# Technical Service Information

## FORD 4R70E/4R75E DTC P0715/P0717 OR ERRATIC SHIFTS

Figure 1

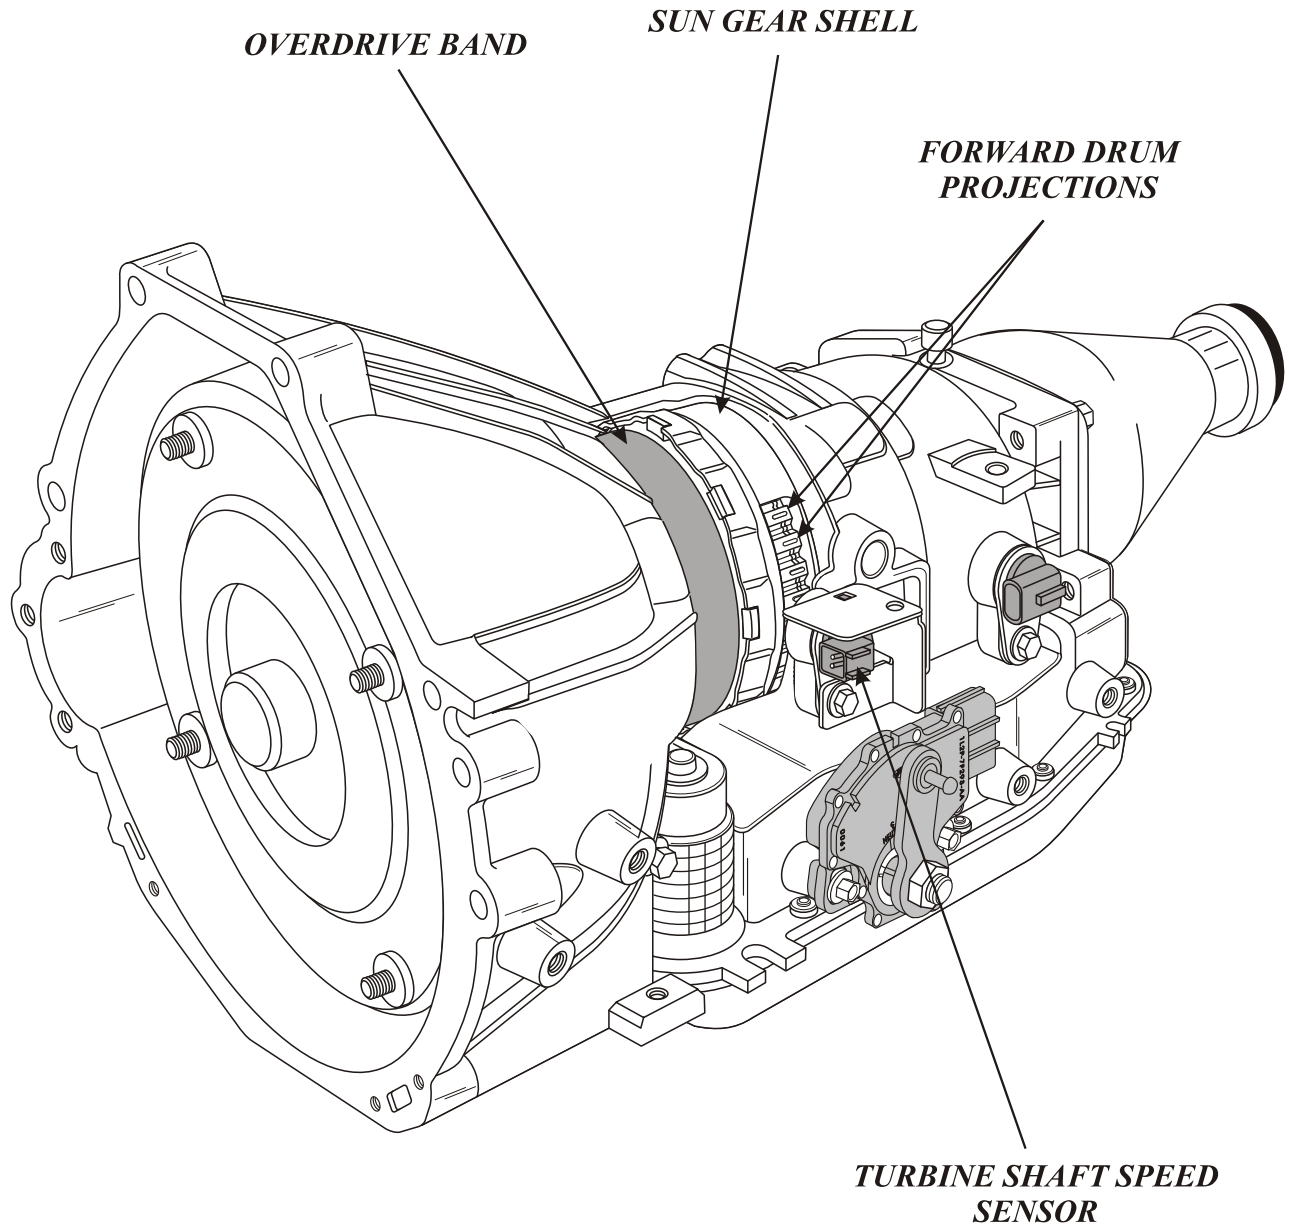
**CAUSE:** The cause may be, that the Forward Clutch Drum, as shown in Figure 2, or Sun gear Shell, as shown in Figure 3, were replaced with the previous design parts causing the Turbine Speed Sensor to return a false reading to the Powertrain Control Module. In the start of production for 2004 the Sun gear shell was made of a non-magnetic material to allow the new Turbine Shaft Speed Sensor to read the Forward Clutch Drum, calculating Turbine shaft speed for the PCM. At the same time the Forward Clutch Drum received a new stamping process, to provide 34 projections for the sensor to read from. See Figure 1 for a cross-sectional view.

Figure 2

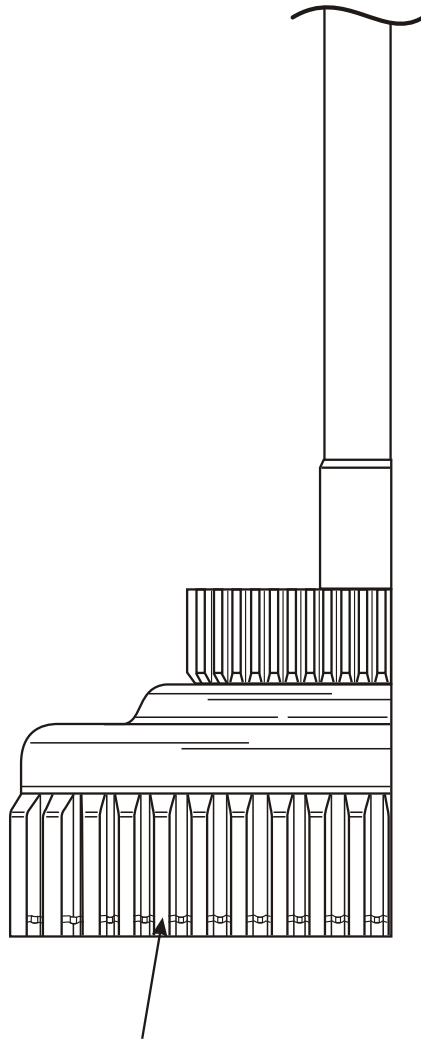
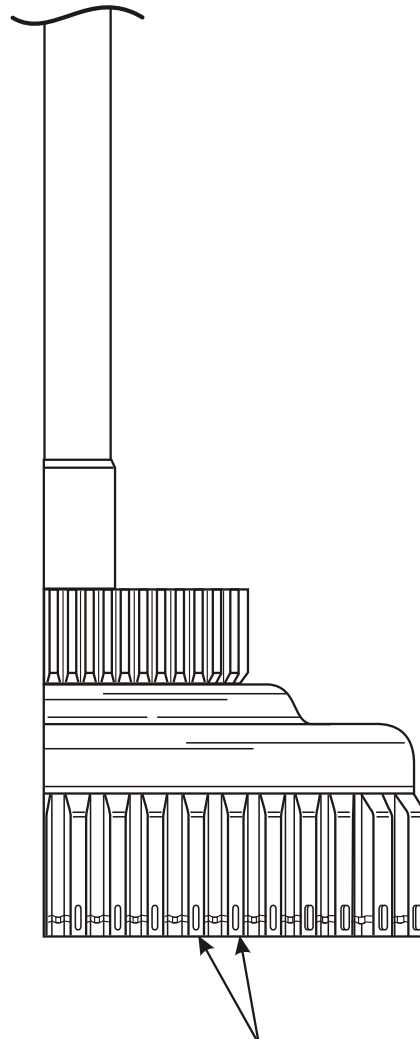
### *PREVIOUS DESIGN*

***NO PROJECTIONS***

### *NEW DESIGN*

***34 STAMPED PROJECTIONS  
ON THE OUTSIDE OF THE DRUM  
THAT THE ADDED TURBINE SENSOR  
READS FROM***

**CORRECTION:** Install the correct Forward Clutch Drum or Sun gear shell into the transmission and or replace the Turbine Shaft Speed Sensor as shown in Figure 4.

FORWARD CLUTCH DRUM.....	3L3Z-7F207-AA
SUN GEAR SHELL.....	5L3Z-7A019-AB
TURBINE SHAFT SPEED SENSOR.....	3L3Z-7H103-AA

Figure 3

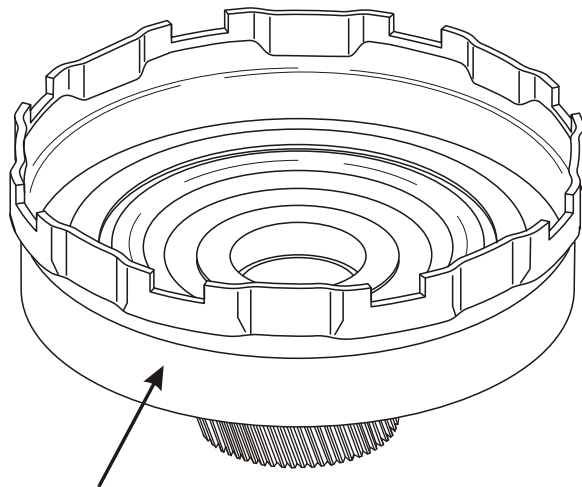
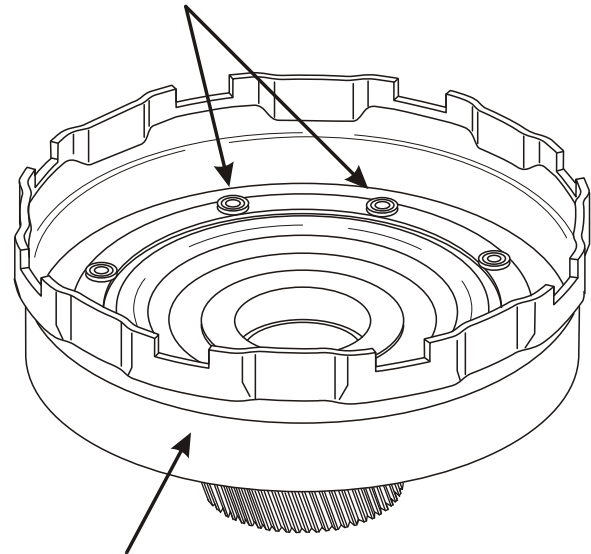
### *PREVIOUS DESIGN*

*MAGNETIC SHELL*

### *NEW DESIGN 4L3Z-7A019-BA*

*New Sun Shell Is Now Riveted  
To The Sun Gear And Hub*

*NON-MAGNETIC SHELL*

*NOTE: The New Sun Shell is made from  
a non-magnetic material so the Turbine sensor  
can read the Forward drum.*

*2005 models use the same type of Sun Shell  
and there are no rivets for identification.*

*Ford Part number 5L3Z-7A019-AB*

Figure 4

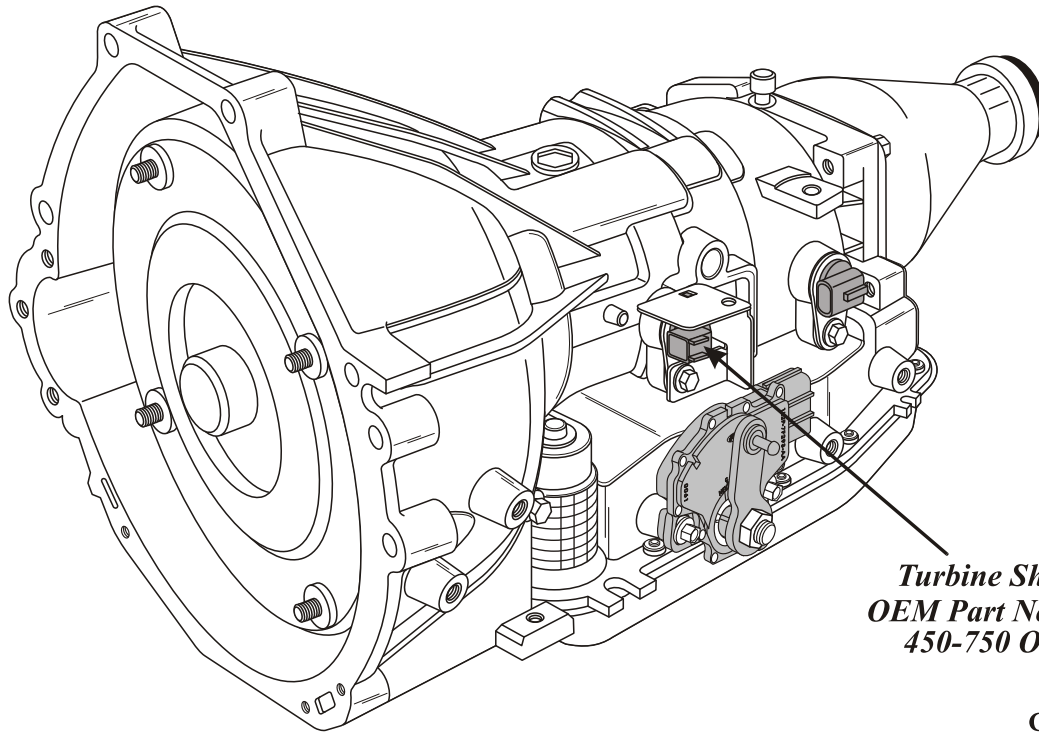
*Turbine Shaft Speed Sensor  
OEM Part No. 3L3Z-7M101-AA  
450-750 Ohms Resistance*
